HISTORIC PRESERVATION BOARD

STAFF REPORT

ITEM: 27 – 43 South Swinton Avenue & 104 SE 1st Avenue, Swinton Social, Old School Square Historic District – Certificate of Appropriateness, Class V Site Plan, and Waivers (2011 – 178) for the establishment of spa and restaurant uses, and a valet parking lot.

6 EAST ELEVATION (FACING ALLEY)

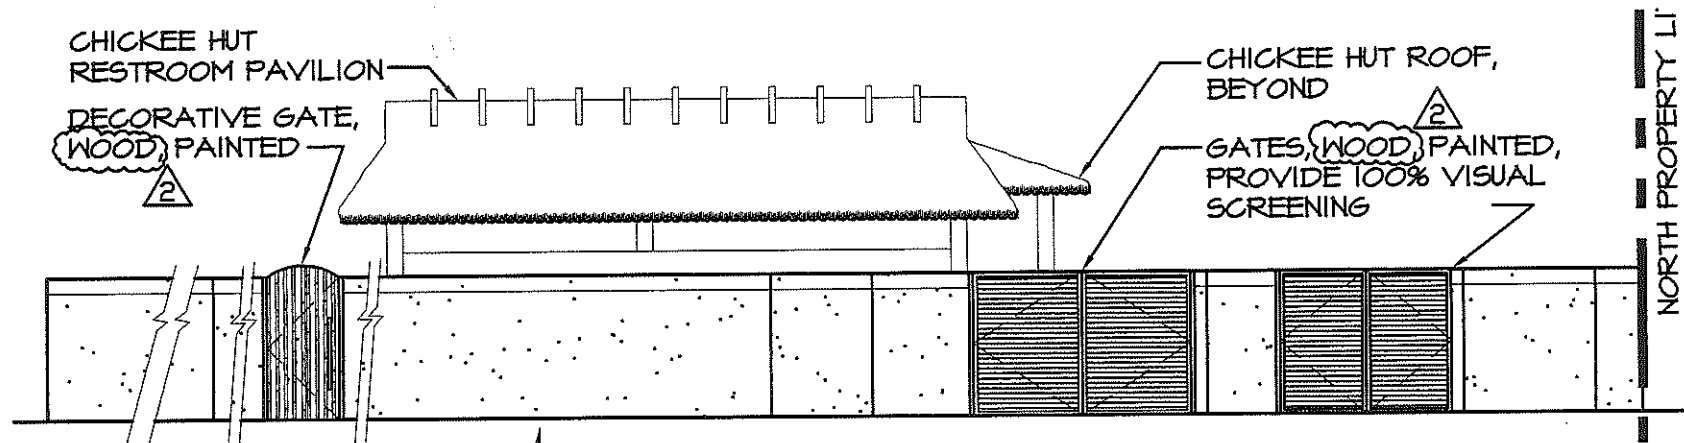
CANVAS AWNING
ADDED ONTO SHEET A3 OF 4

PROPOSED EAST ELEVATION (FACING INTERIOR OF SITE)

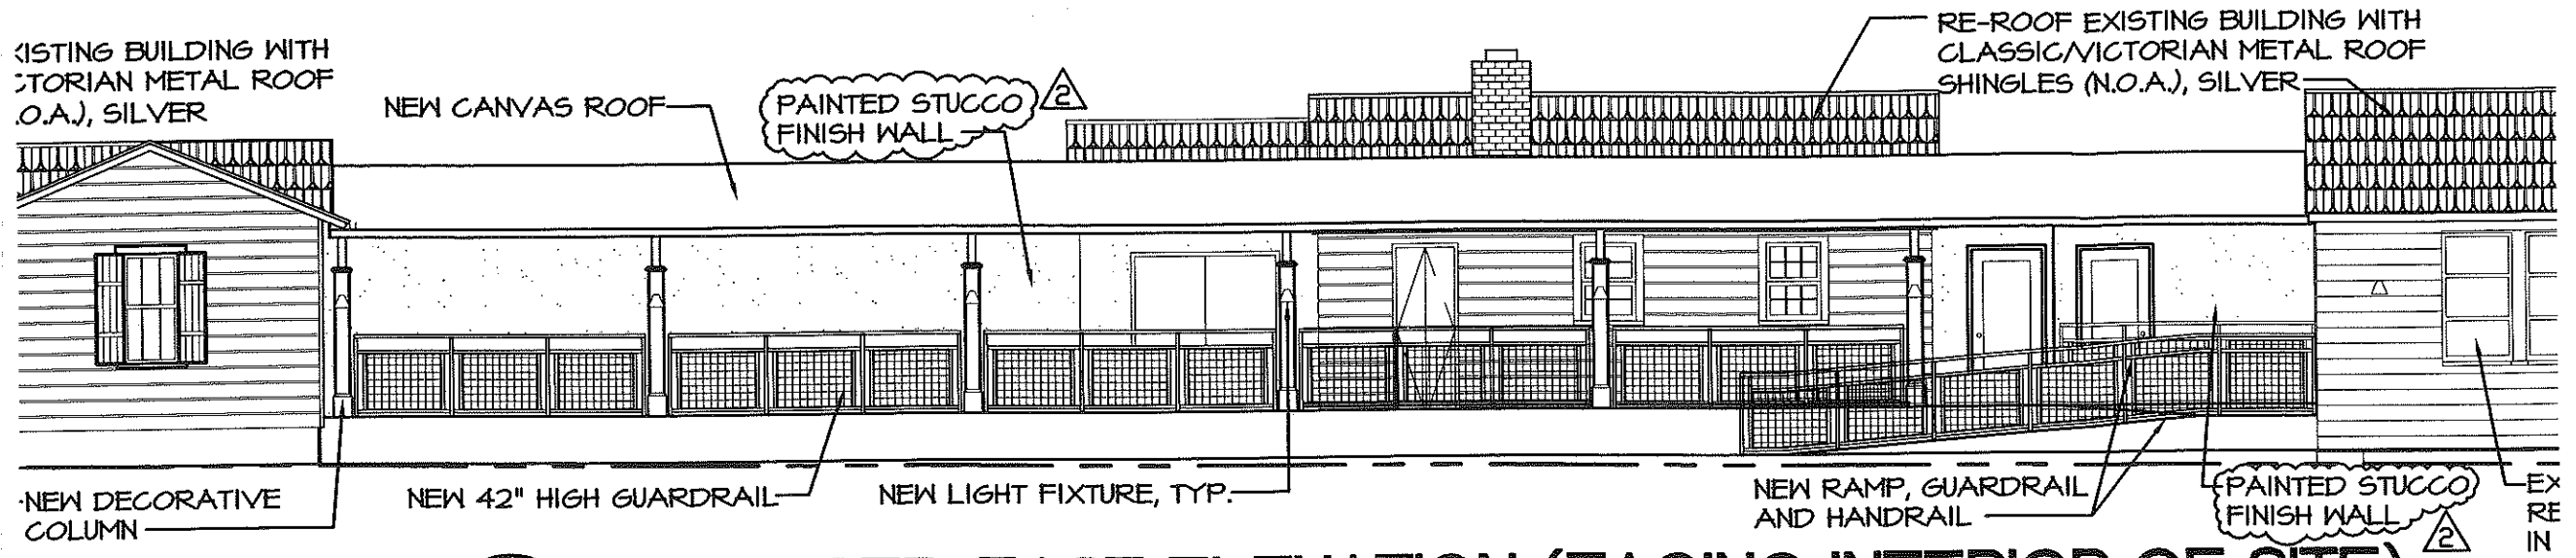
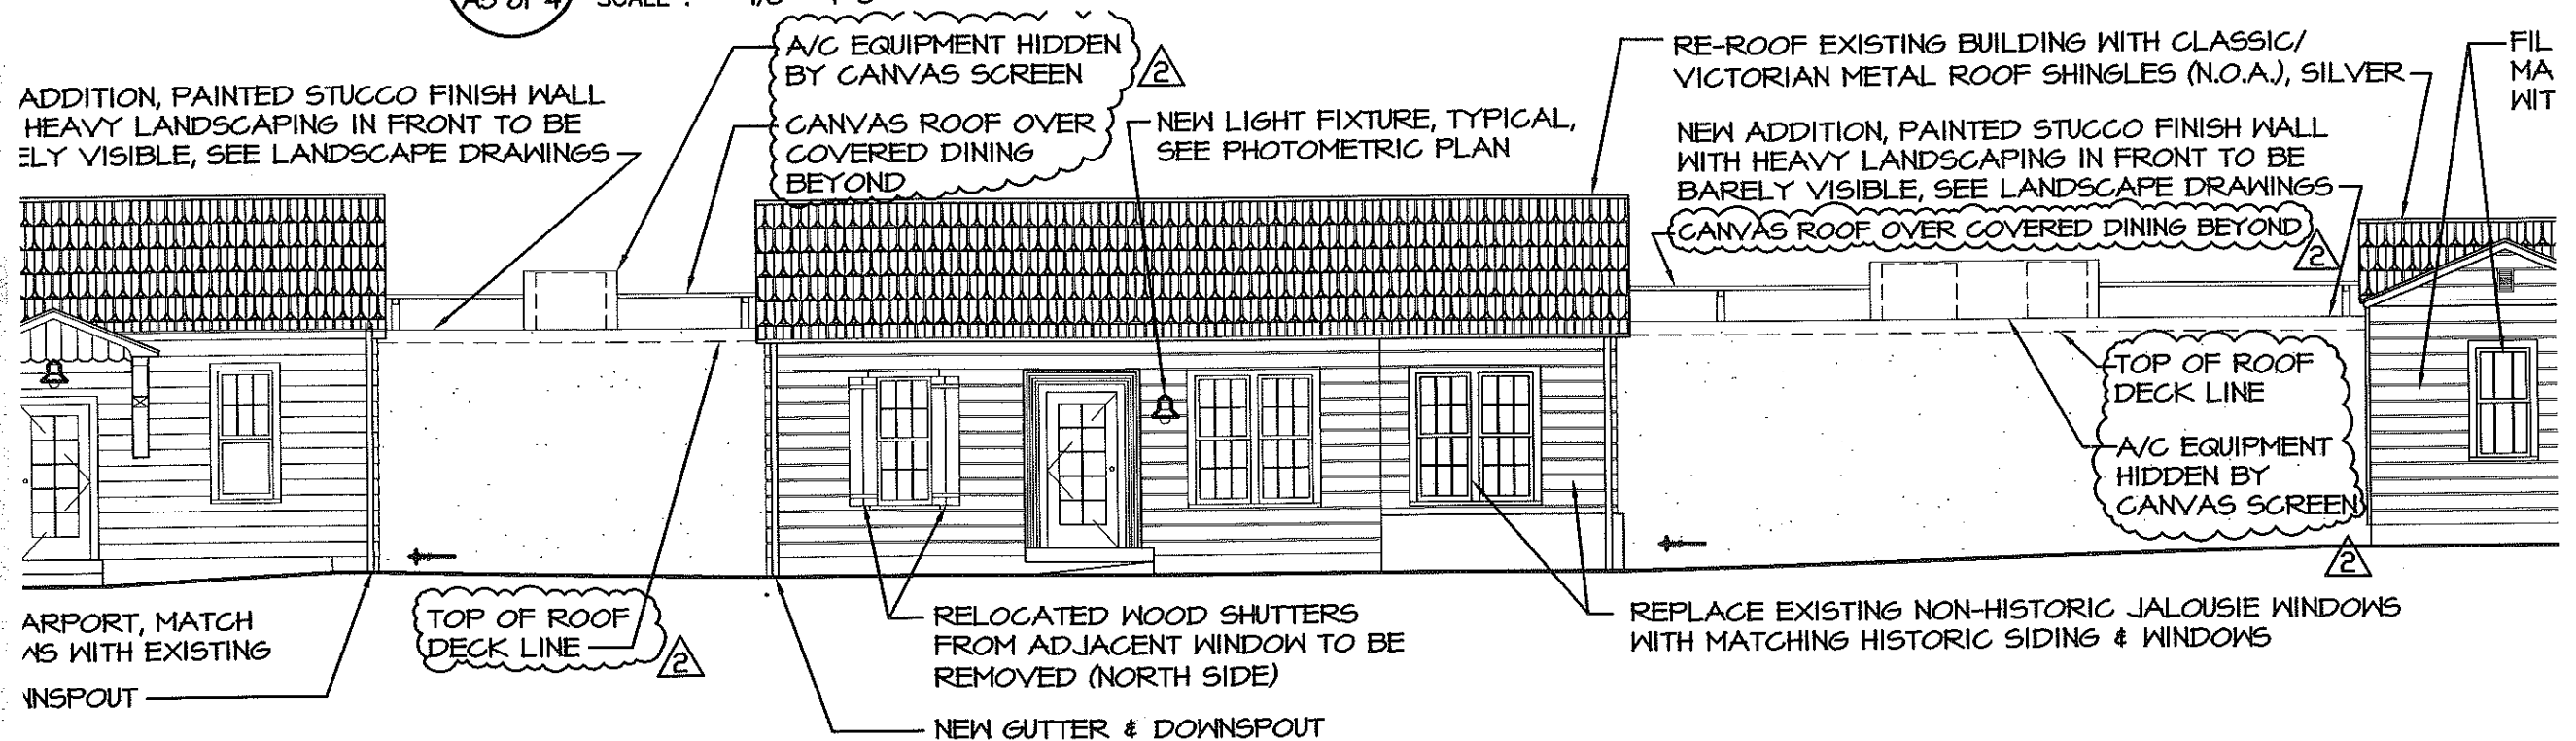
REVISED ON SHEET A3 OF 4
